## ADDENDUM 1

To the Contract Documents for the New Parking Lot

Grand Terrace Elementary School  
Colton Joint Unified School District  
SGH Architects Project Number: 22-12105-04  
DSA A#04-122929

**A1.23**

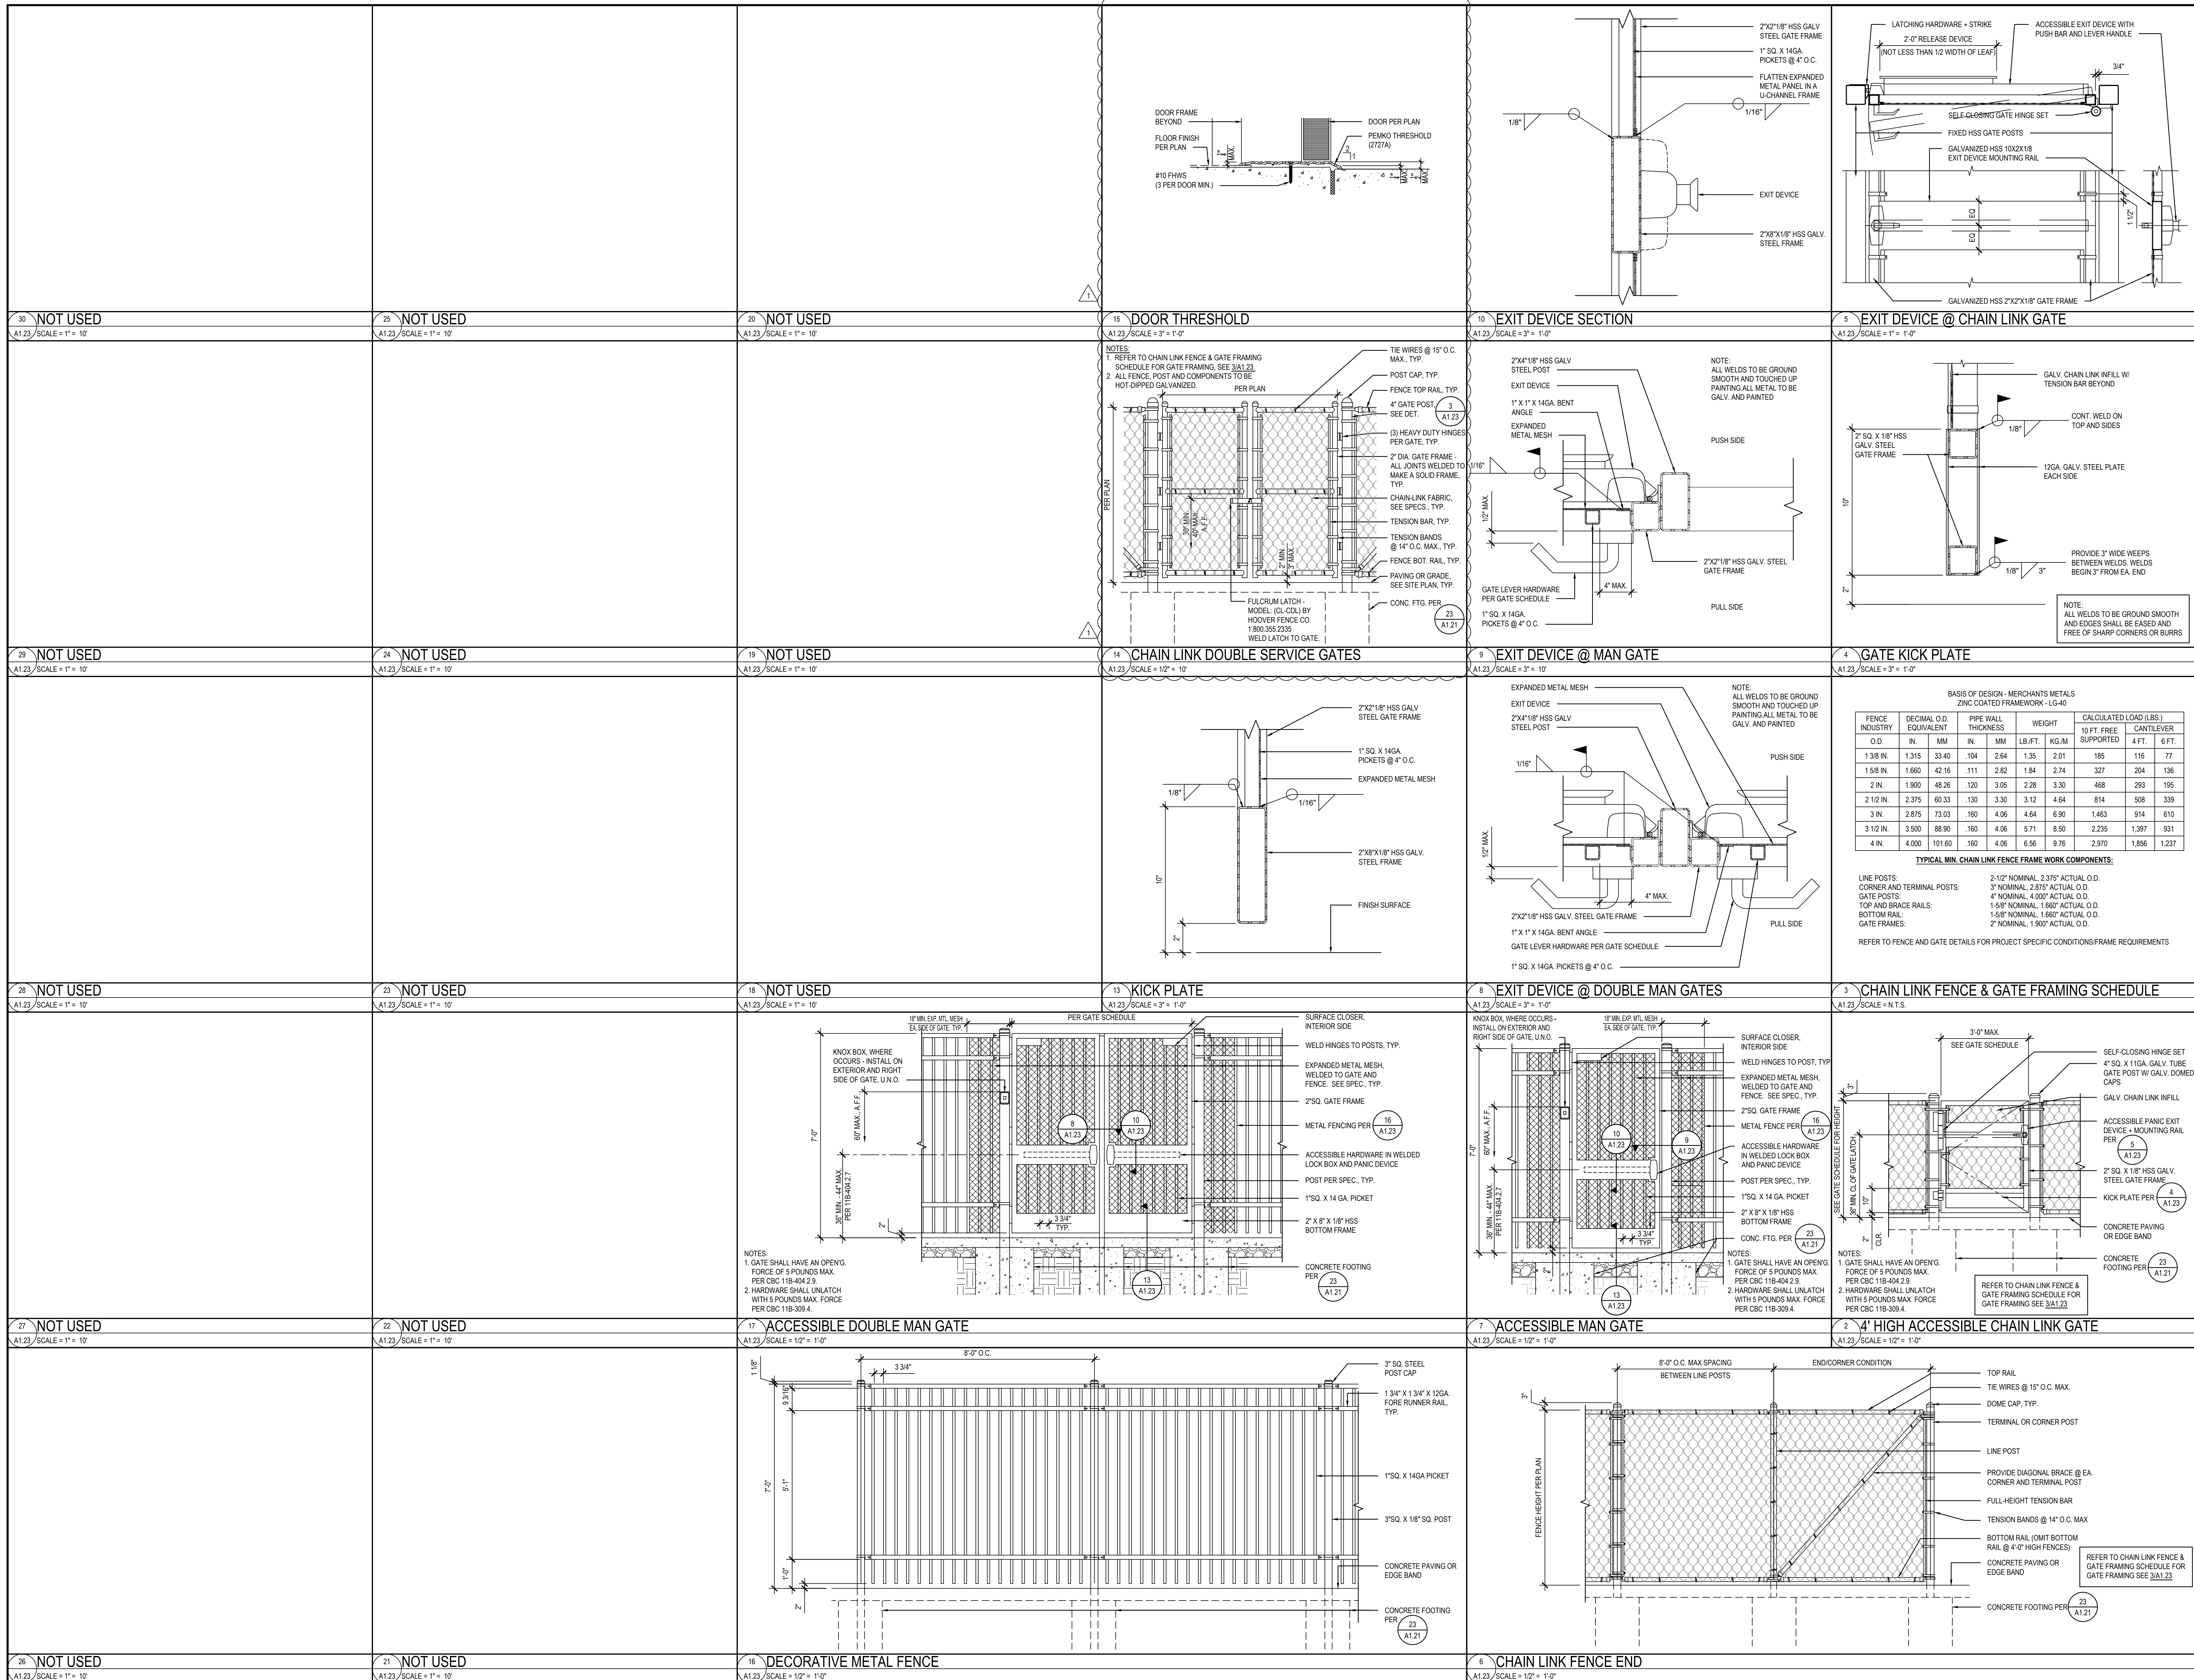
- M. Sheet A1.23 – Site Details-Fencing  
(Attachment 17)
- a. Added new Chain-link Double Service Gates detail #14.
  - b. Added new Door Threshold detail #15.

1 ELECTRICAL SITE PLAN  
E0.10 / SCALE: 1" = 30'-0"

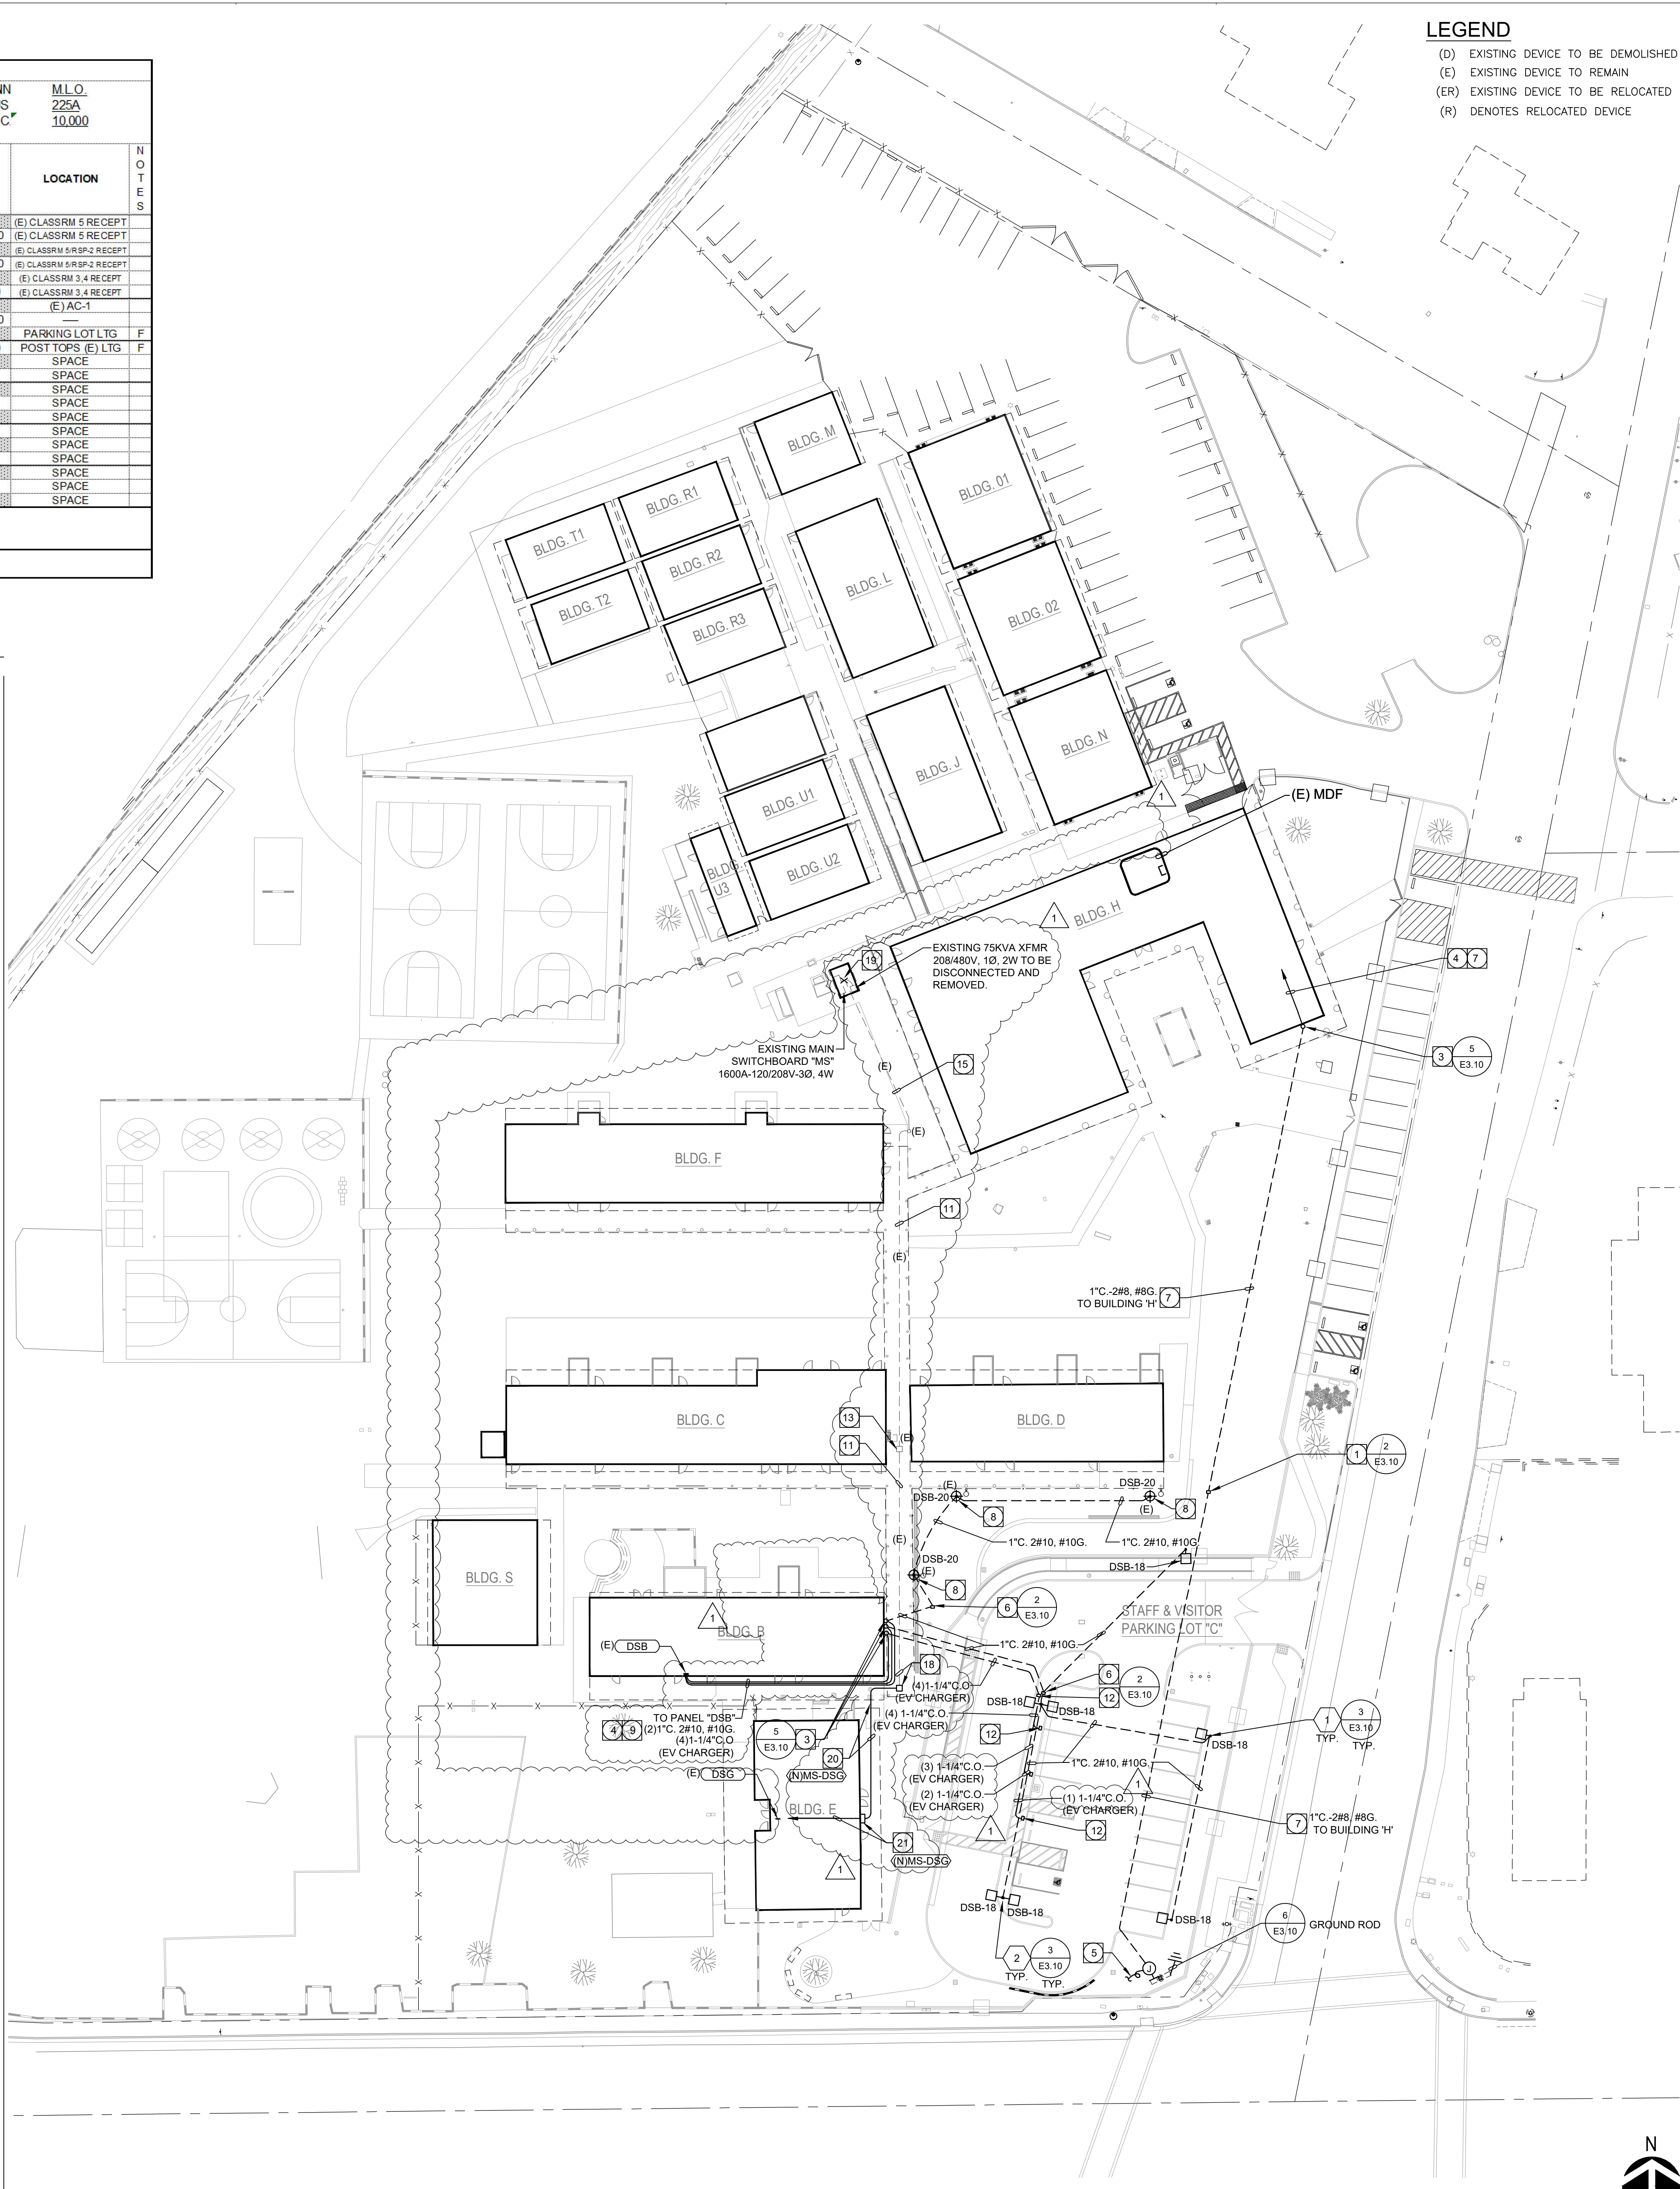
- N. Sheet E0.10 – Electrical Site Plan  
(Attachment 18)
- a. Revised Single Line Diagram to show backfeed of Building E.
  - b. Provided routing of new and existing conduit for backfeed of Building E.

- c. Revised Single Line Diagram Plan Note 1.
  - d. Revised Plan Notes 13 through 18.
  - e. Added Plan Notes 19 through 21.
  - f. Revised conduit callout for future EV Chargers from 2" C.O. to 1 1/4" C.O.

- g. Revised routing of EV Charger conduit and lighting conduits to go under canopy at Building B to panel DSB.
- O. Sheet P0.01 – Legends and Notes  
(Attachment 19)

PLUMBING SITE PLAN

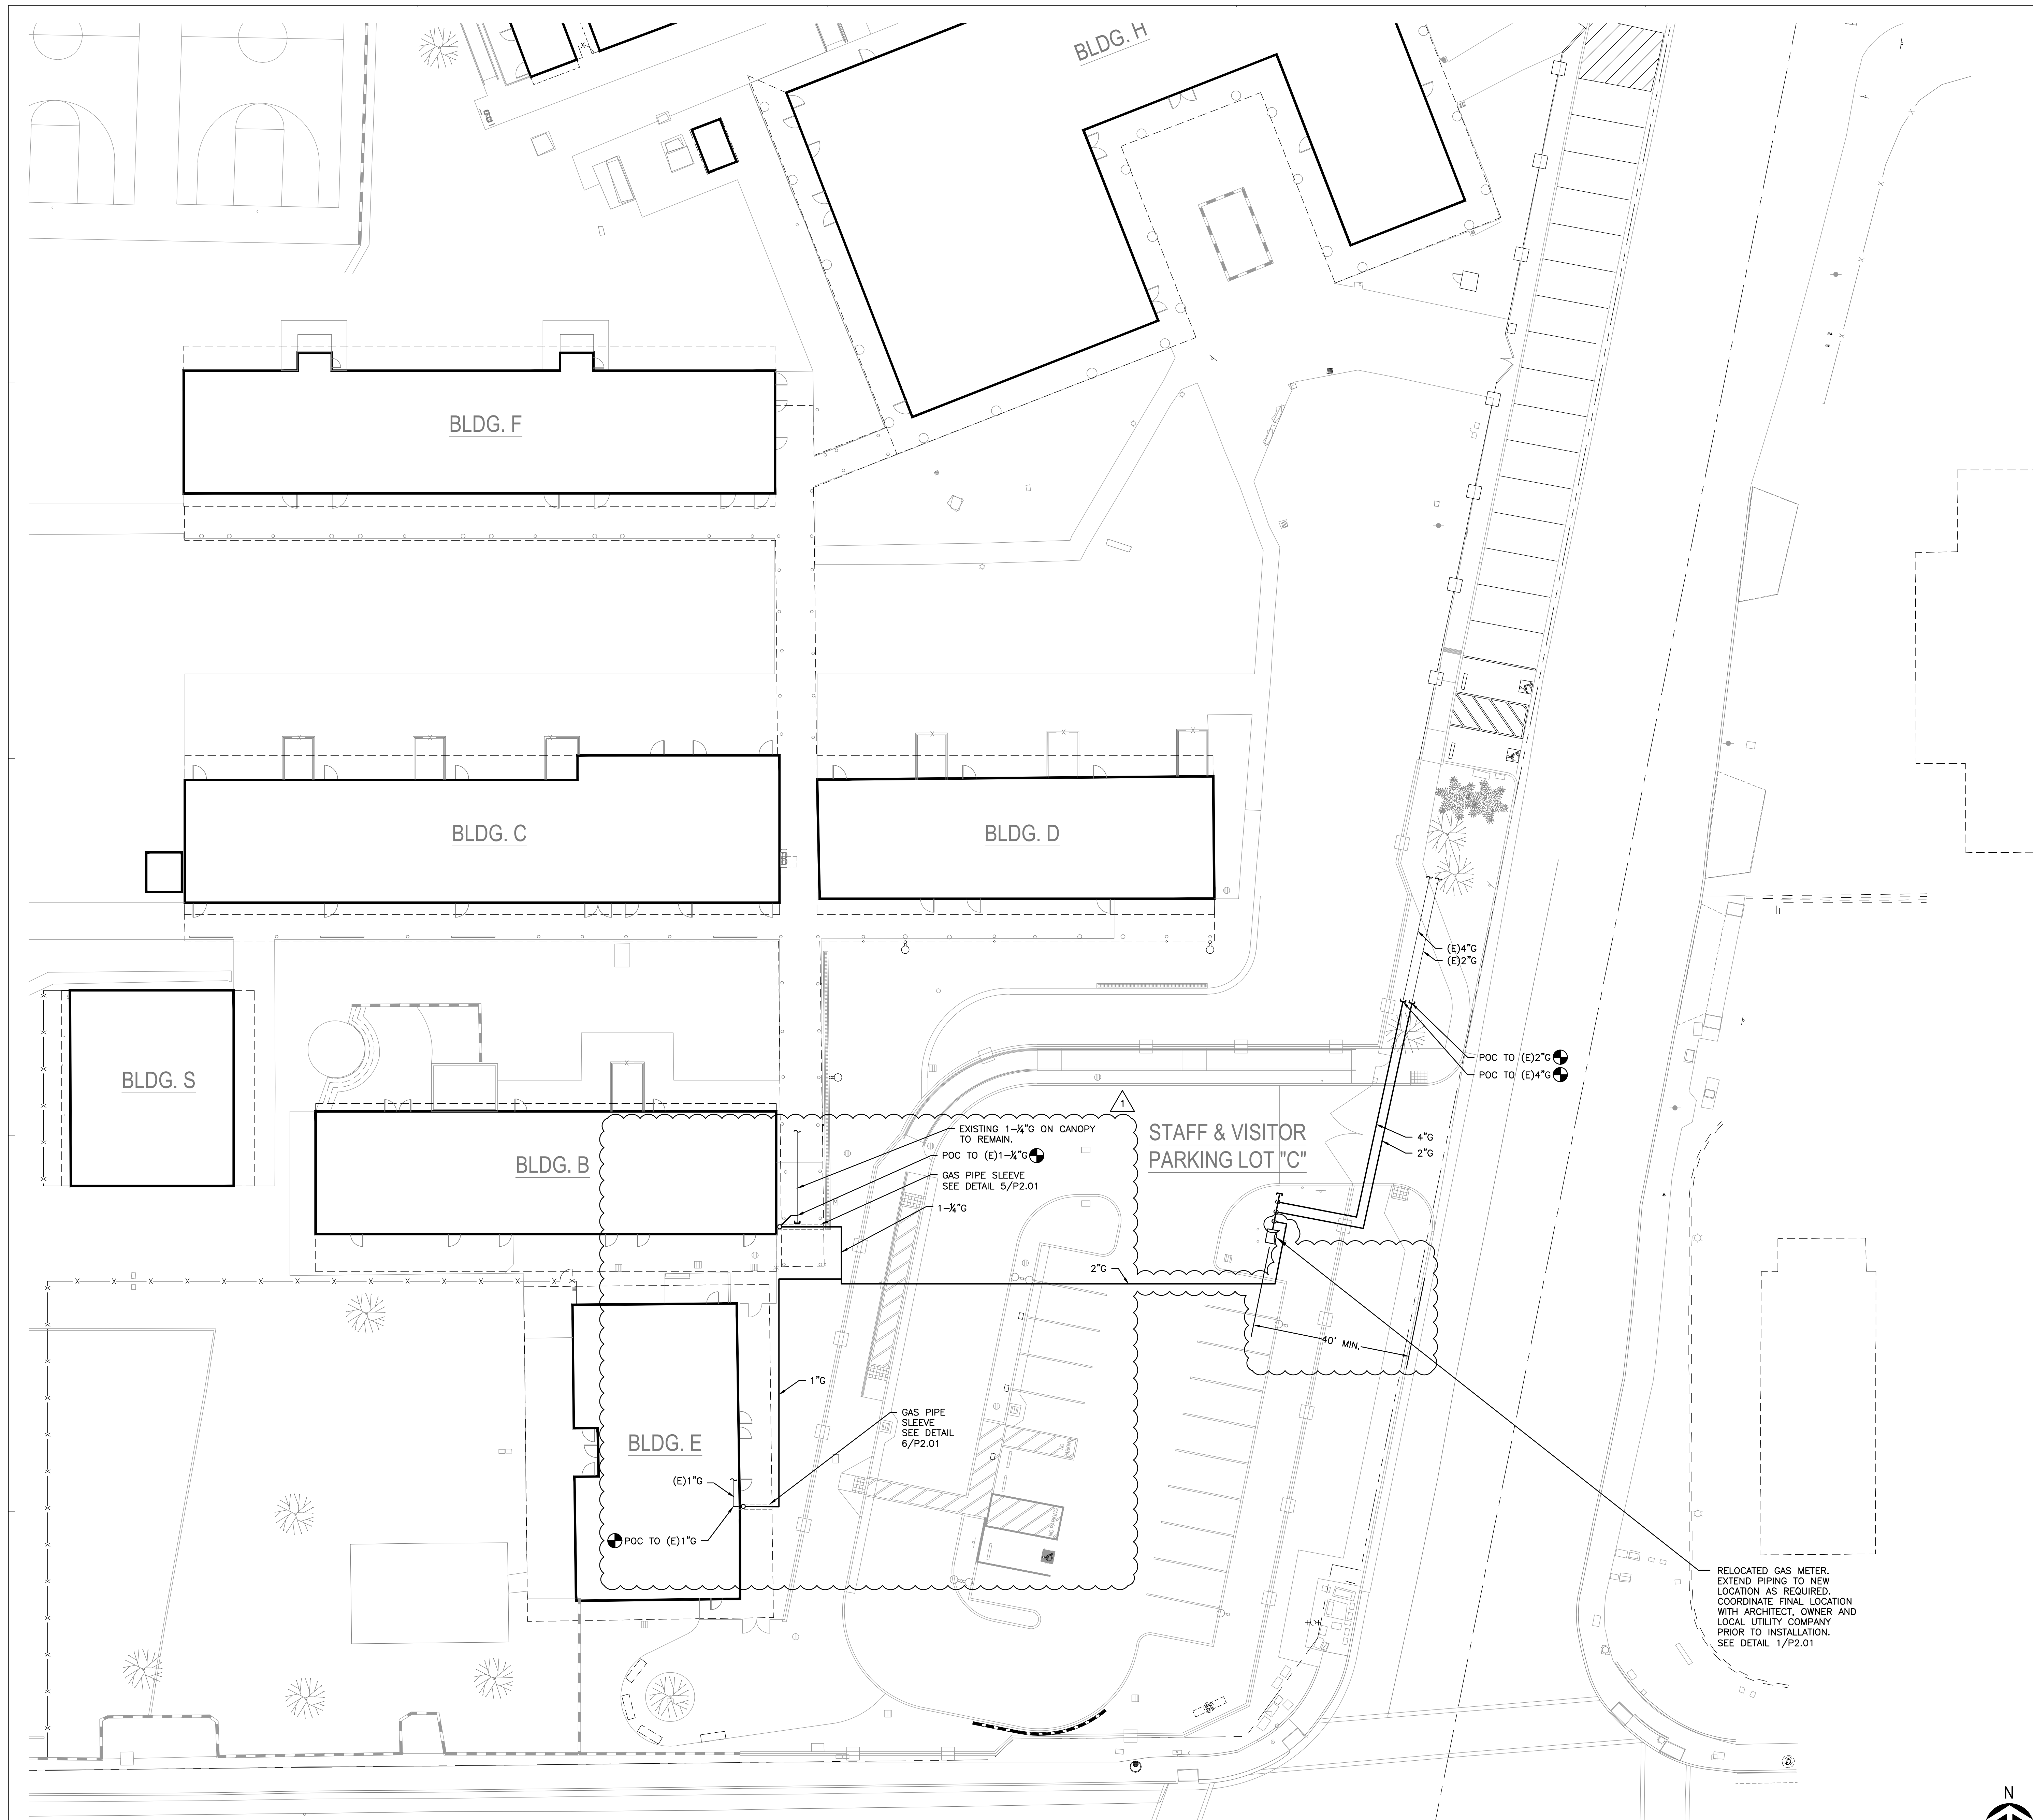
- a. Added new gas pipe to come up next to building and up to existing canopy cover for new point of connection.
  - b. Added a 1" branch from 2" underground gas to serve existing Building E.
